Subject: NRC Meeting At Westinghouse 4/8/92
 Review Progress On Solvent Extraction
 Contamination Problem

On April 8, 1992, Tom Decker, U. S. Nuclear Regulatory Commission, visited the site to review the Westinghouse facility with respect to the problems noted in the solvent extraction area soil contamination incident and the response.

"HYDROCONE" AND AUGER SOIL SAMPLING LOCATIONS

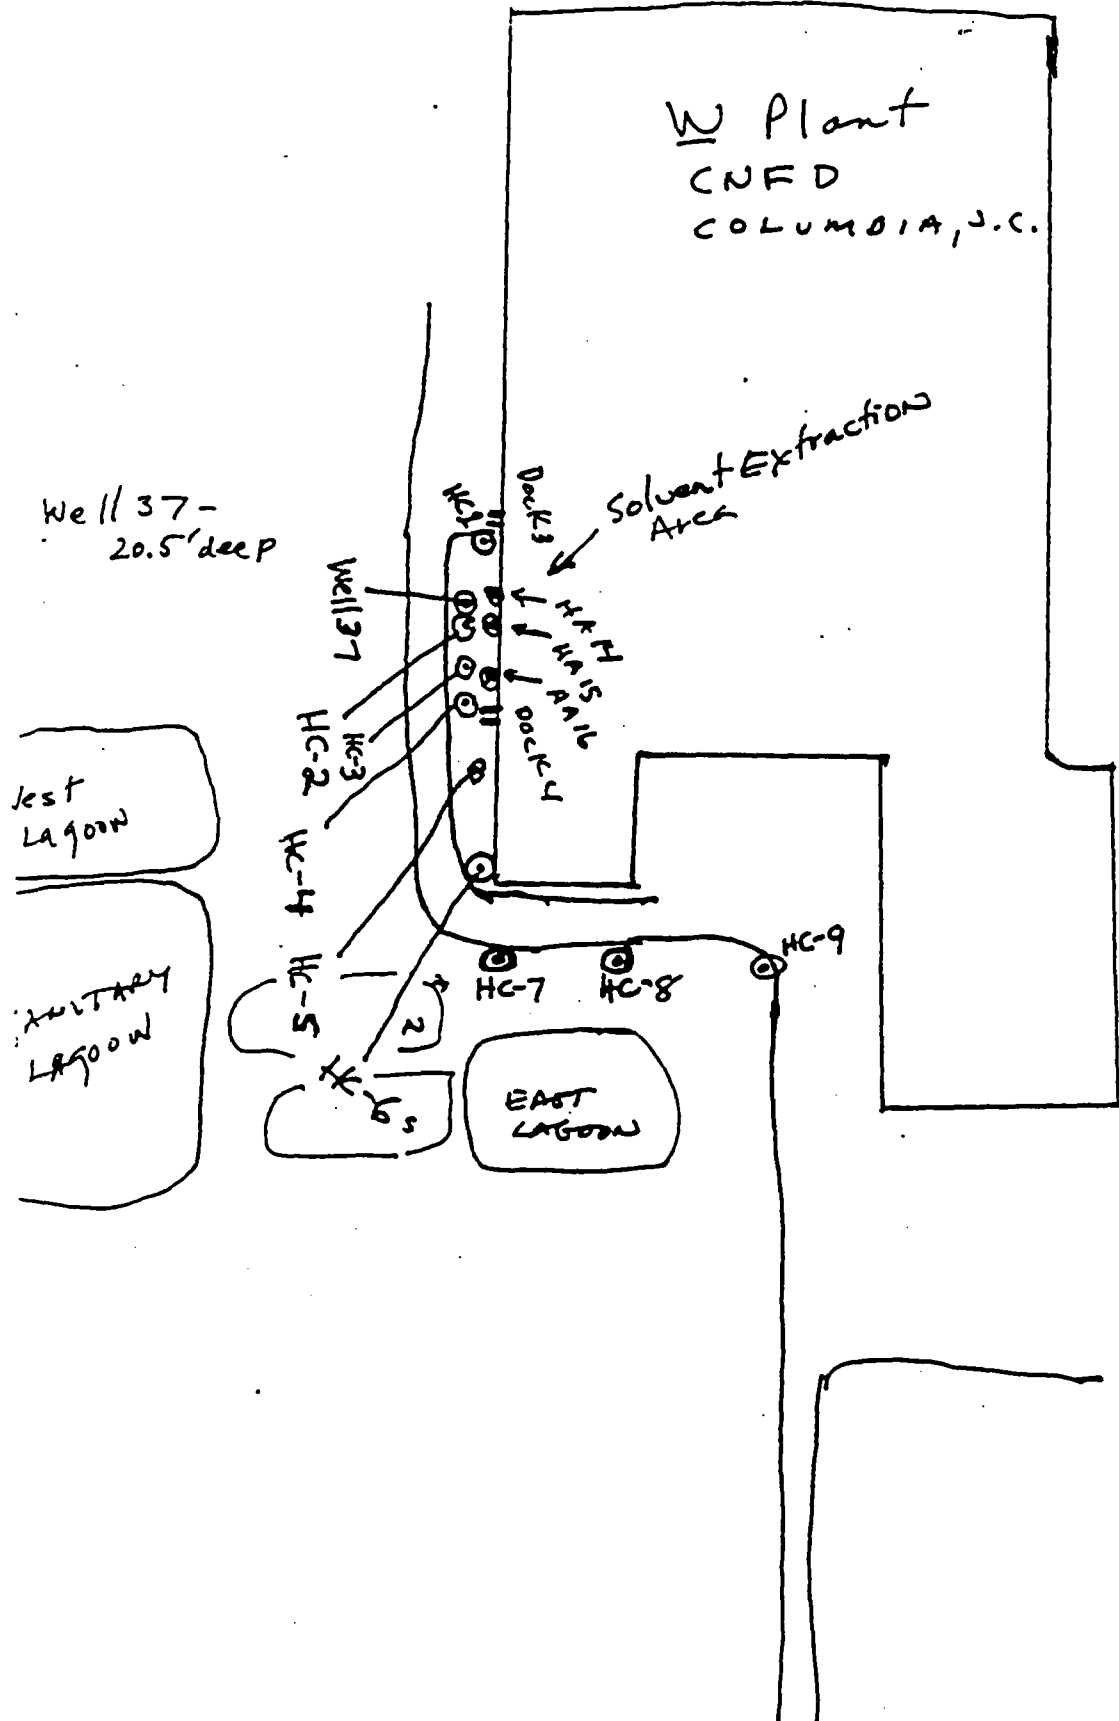
1. Evaluate the depth of the footers
2. Evaluate migration down the footers
3. Indicate site characterization numbers if any in report
4. Leak control procedure formalization
